UNITED STATES PATENT AND TRADEMARK OFFICE

Office Action Summary	Application No. 10/696,583	Applicant(s) FARRELL ET AL.	
	Examiner William V. Gilbert	Art Unit 3635

DETAILED ACTION

Figure 6 from Sacks

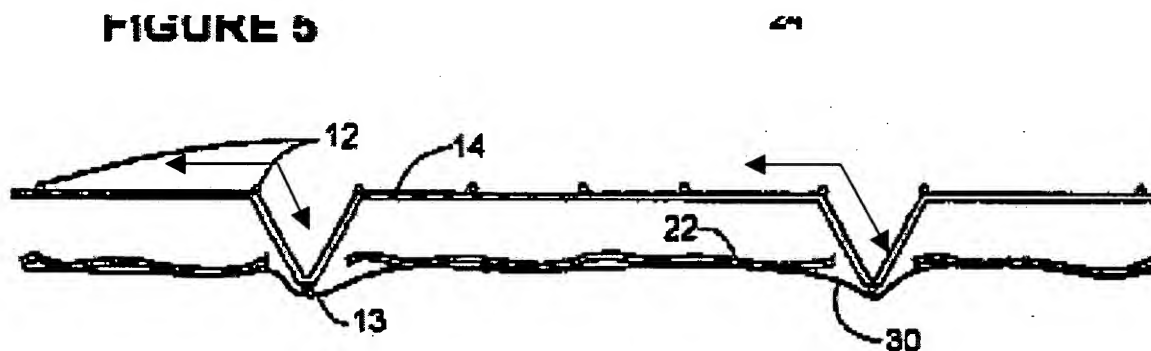
Claim 5: while the ridges in Chen in view of Sacks are V-shaped (see Figure 1, below for clarification), and have a depth of about $\frac{1}{2}$ inch (Col. 7, lines 3 and 4), the specifics of the dimensions of the width of the panel. It would have been obvious at the time the invention was made to a person having ordinary skill in the art as a matter of design choice to have these dimensions because Applicant failed to state a criticality for the necessity of these limitations and the prior art of record is capable of conforming to the limitations.

Claim 6: Chen in view of Sacks discloses 2 parallel V-Shaped impressions (see above) defined in at least the outer wire mesh member.

Claim 10: Chen in view of Sacks discloses an outer layer (Chen: Claim 8), but not that the V-shaped impressions are used as a screed. It would have been obvious at the time the invention was made to a person having ordinary skill in the art to use the V-shaped impressions (see above) as a screed in order to prevent the waste of stucco applied to the surface.
